Re: Bus Connects Templeogue/Rathfarnham to City Centre Core Bus Corridor Scheme
Templeogue/Rathfarnham to City Centre

**Re: Templeogue/Rathfarnham to City Centre Bus Corridor – ABP 316272-23
Plot No. 1026 – 55 Rathfarnham Road, Terenure, Dublin 6W**

Submission on the proposed
construction of the Templeogue/
Rathfarnham to City Centre Core
Bus Corridor

TEMPLEOGUE/RATHFARNHAM TO CITY CENTRE - CORE BUS CORRIDOR SCHEME
REVIEW ON BEHALF OF #55, #59, #61, #63, #65, #67 & #71 RATHFARNHAM ROAD:
BASED ON AVAILABLE DESIGN DETAILS AND TOPOGRAPHICAL SURVEY

Figure 2 – Profile for #55 Rathfarnham Road

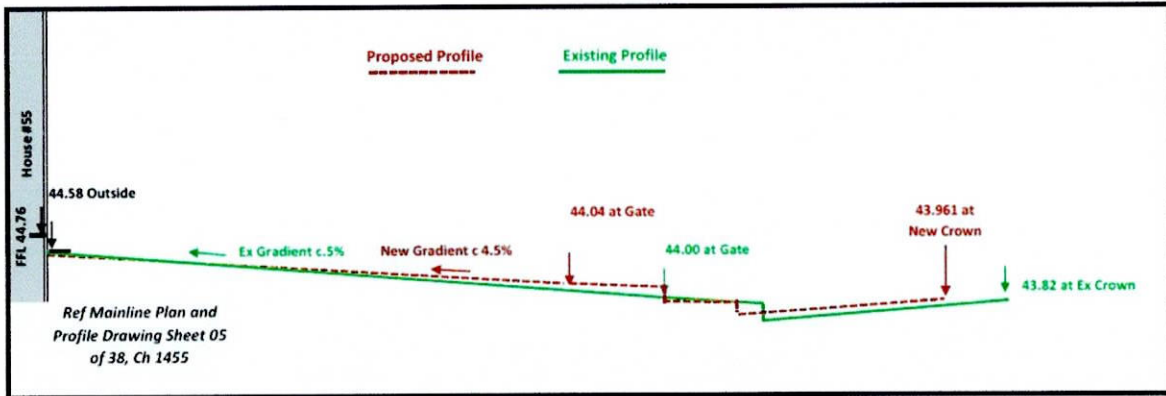
House Details	Current Total Gradient ¹	Future Total Gradient ²	Comment
55 Rathfarnham Rd	5%	4.5%	Improvement
59 Rathfarnham Rd	7.6%	9.6%	Significantly Steeper
61 Rathfarnham Rd	7.6%	8.9%	Significantly Steeper
63 Rathfarnham Rd	6.3%	10.5%	Significantly Steeper
65 Rathfarnham Rd	9.6%	11.1%	Significantly Steeper
67 Rathfarnham Rd	10.6%	13.6%	Significantly Steeper
71 Rathfarnham Rd	8.2%	9.3%	Steeper

We conclude that the Bus Connect plans (as per the Planning Application, based on the design data provided) appear to result in a significantly steeper approach to the majority of the subject dwellings, clearly contravening National Building Control Regulations.

We would suggest that a comprehensive consequential design for pedestrian and vehicular access from the public road to the door of each house, that meets the Part M requirements, should be provided demonstrating to An Bord Pleanála and each resident that this has been adequately addressed.
